Groundwater Transfer Review Summary Form

Transfer/PA # T- 14545

Application: T-14545

Applicant Name: Davenport Newberry Holdings Inc

Water Levels in Adjacent Observation Wells

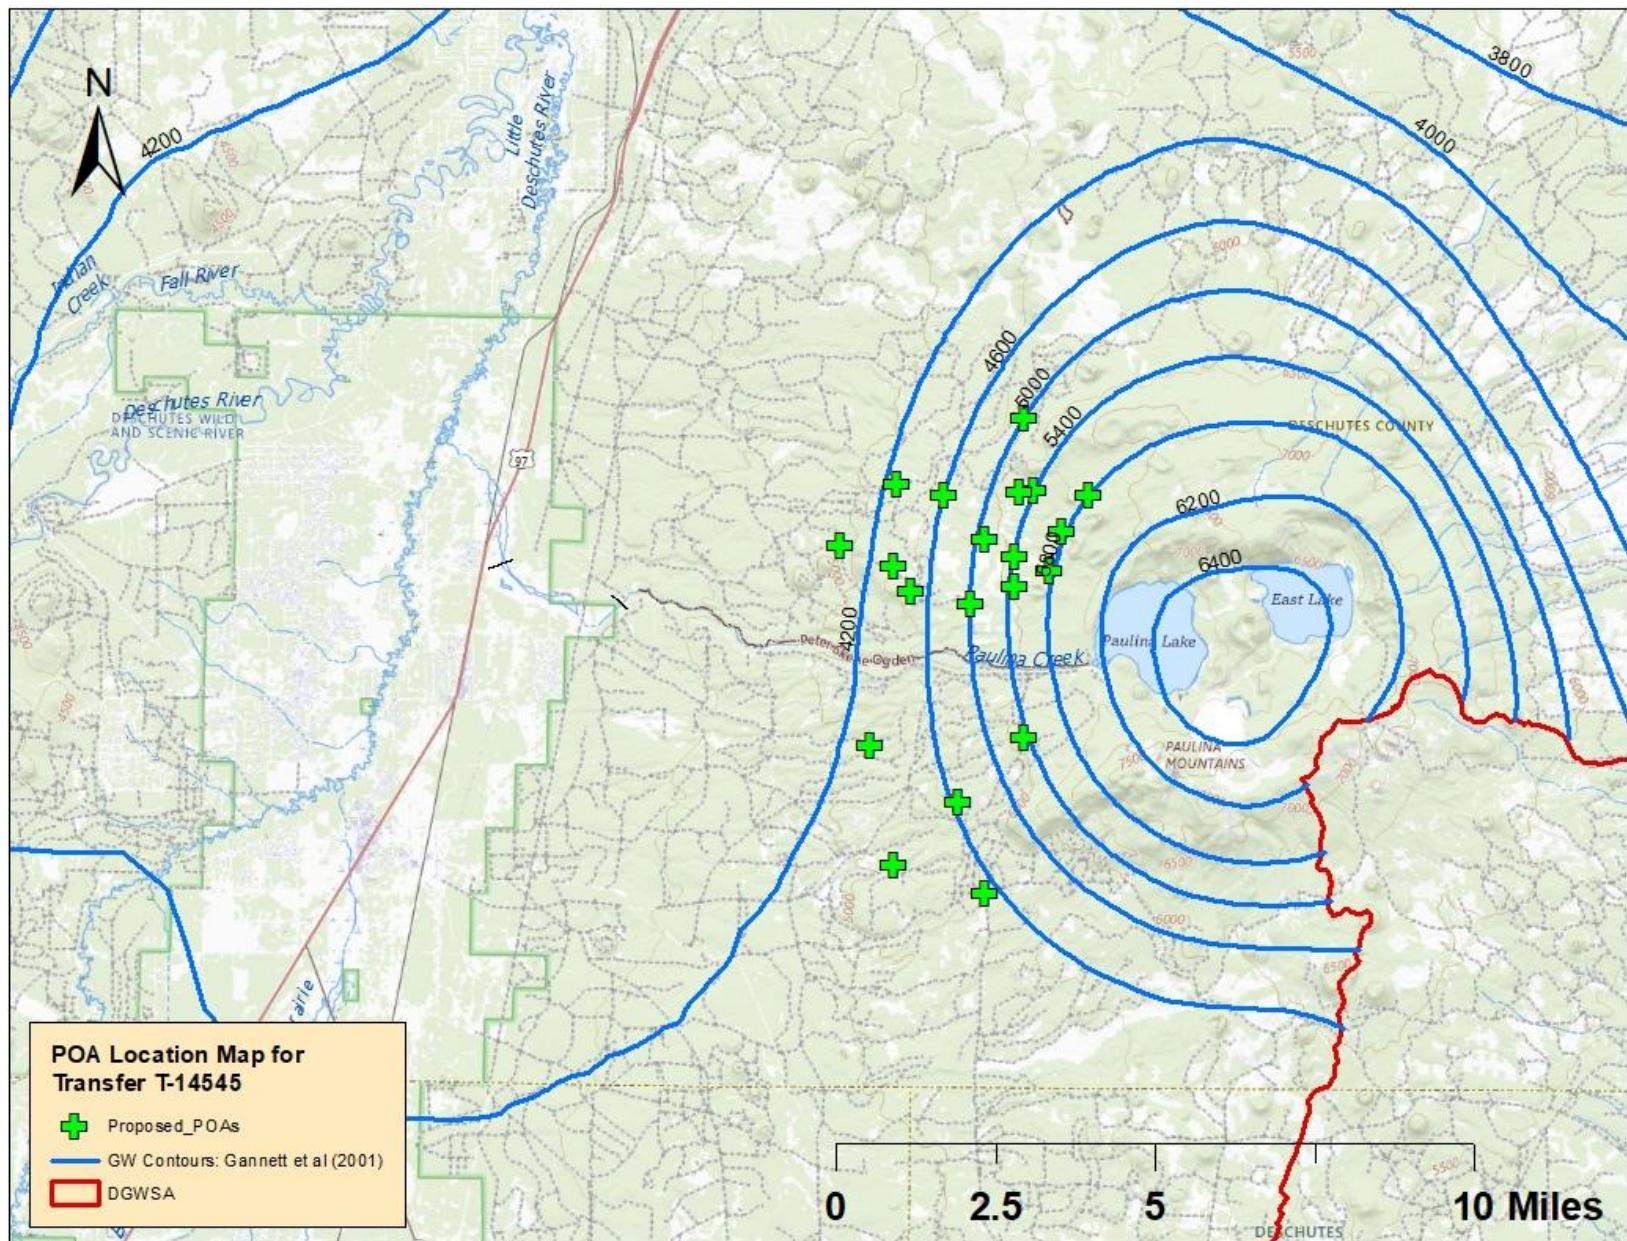
- b) If yes, for each POA identify the reference level, most recent spring-high water level, and whether an applicable permit decline condition has been exceeded: The table below has all reference level and decline designations. There is very little seasonal fluctuation in the target aquifer and the site is often not accessible due to snow. As a result, reference level or recent levels are taken from any time during a given year. At this time, no decline thresholds have been exceeded.
